UNITED STATES PATENT AND TRADEMARK OFFICE

APPLICATION NO.	FILING DATE	FIRST NAMED INVENTOR	ATTORNEY DOCKET NO.	CONFIRMATION NO.
10/561,532	12/19/2005	Ronald Dekker	NL02 1153 US	9985

Office Action Summary	Application No. 10/561,532	Applicant(s) DEKKER ET AL.	
	Examiner Michael B. Shingleton	Art Unit 2815

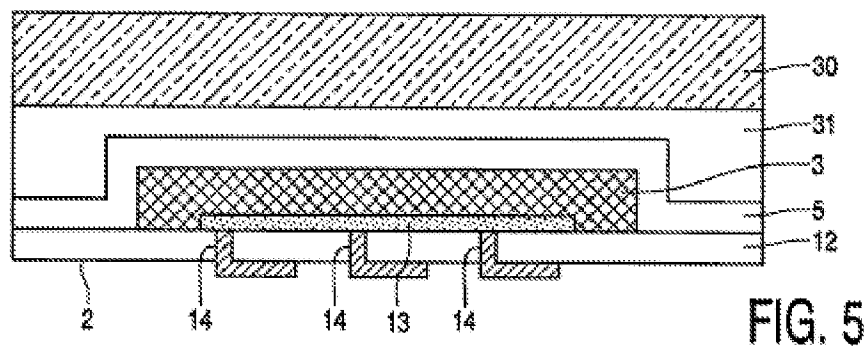
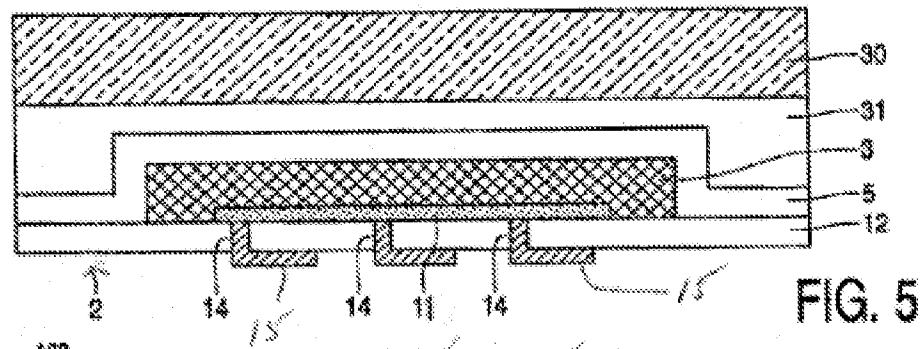
The drawings are objected to as failing to comply with 37 CFR 1.84(p)(4) because there are two different parts shown in newly presented Figure 7 that have the character "50" (Note the upper and lower number 50's.). Different parts cannot have the same reference number See MPEP 608.02 and 37 CFR 1.84. Corrected drawing sheets in compliance with 37 CFR 1.121(d) are required in reply to the Office action to avoid abandonment of the application. Any amended replacement drawing sheet should include all of the figures appearing on the immediate prior version of the sheet, even if only one figure is being amended. Each drawing sheet submitted after the filing date of an application must be labeled in the top margin as either "Replacement Sheet" or "New Sheet" pursuant to 37 CFR 1.121(d). If the changes are not accepted by the examiner, the applicant will be notified and informed of any required corrective action in the next Office action. The objection to the drawings will not be held in abeyance.
